RE: CUYAHOGA COUNTY
CITY OF BEACHWOOD
CONSTRUCTION STORM WATER
EATON WORLD HEADQUARTERS

NOTICE OF VIOLATION

Fig 11 (RIGHT). Sediment was observed at the discharge of Sediment Pond T-1.

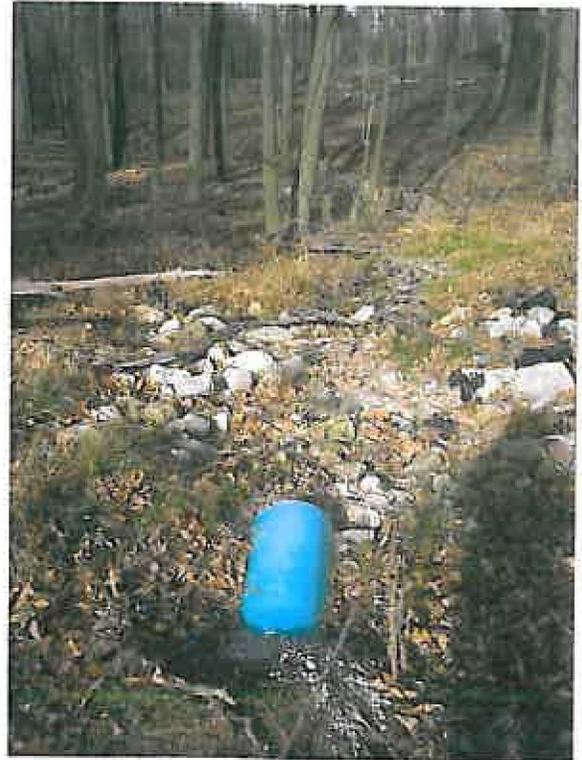
- **Sediment Pond T-1 is not being maintained as a sediment trap as indicated in the SWP3.** Sediment controls must be maintained until their contributing drainage area has been re-stabilized. The drainage area to T-1 remains disturbed. The SWP3 calls for T-1 to be a sediment trap with rock dam outlet and a sediment storage volume below and dewatering volume above the base of the dam. Instead, it appears that you have installed the permanent outlet structure for T-1 and have not modified it so that T-1 can act as a sediment basin. Please consult with your project engineer and the enclosed specifications for sediment basins found in *Rainwater and Land Development, Ohio's Standards for Stormwater Management, Land Development and Urban Stream Protection* (Ohio Department of Natural Resources, 2006) to determine how to amend the permanent outlet structure of T-1 to mimic a sediment basin.
